Re: Sampling Approach in Support of Bioavailability Study, Midland Area Soils

Sampling Approach in Support of Bioavailability Study, Midland Area Soils

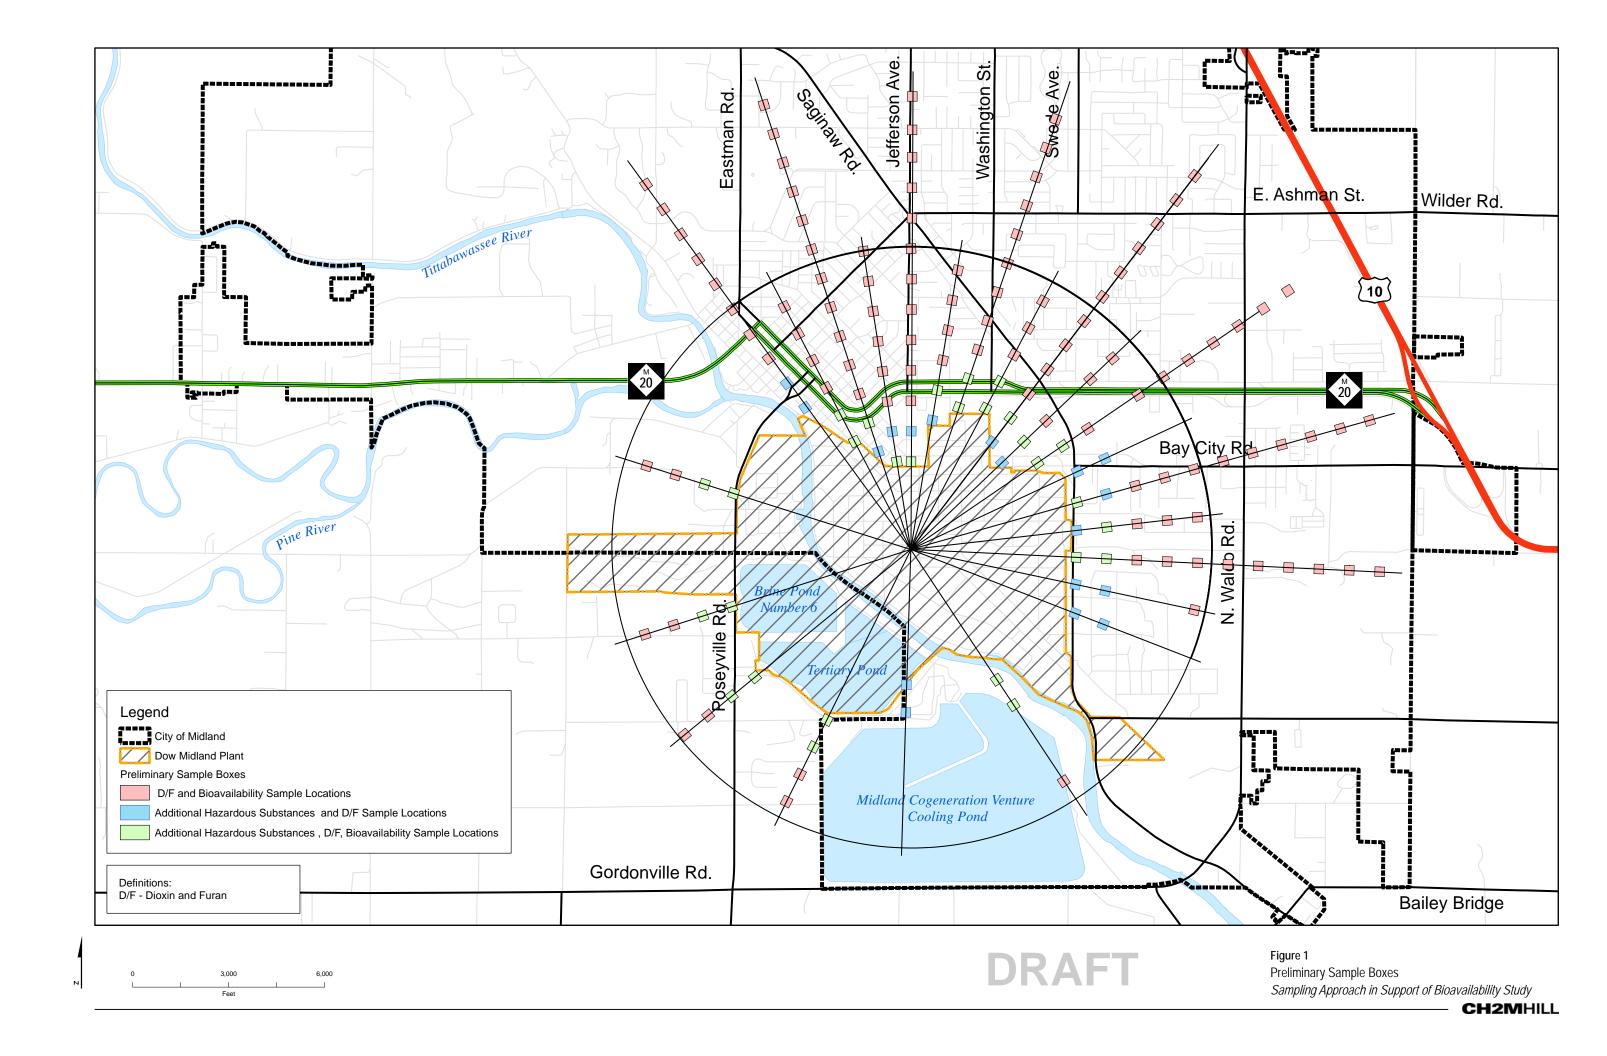
The sampling pattern shown in Figure 1 consists of 23 radial transects extending from the Dow Midland Plant site. This design accounts for multiple sources at the site, with aerial deposition of hazardous constituents to surface soils as the primary transport mechanism. The sampling design is based on meeting the objective of providing additional information on hazardous substances in the study area, but is expected to also be sufficient for providing information on soil characteristics in support of the Bioavailability Study.

Figure 2
Conceptual Example of Adjusted Sample Boxes
Sampling Approach in Support of Bioavailability Study

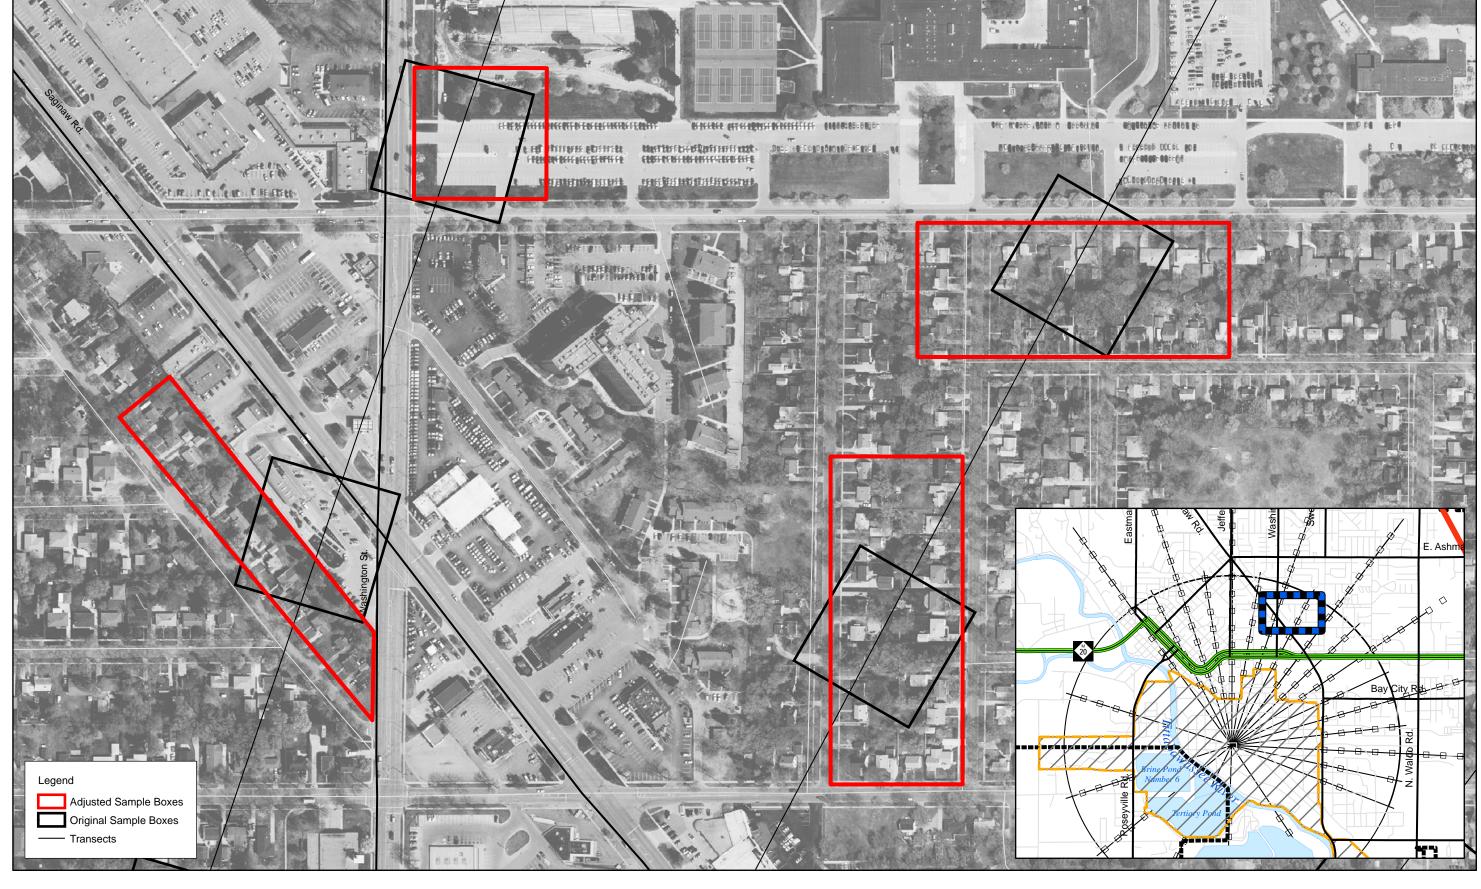
- The sample station "boxes" will be adjusted based on actual site conditions to 1) ensure an adequate number of properties are included within the station to protect the anonymity of the property analyzed and 2) capture properties of a similar land use where possible. Figure 2 provides a conceptual example of how the sample station "boxes" might be adjusted. The final locations and extent of each sample station will be developed jointly with and approved by MDEQ.
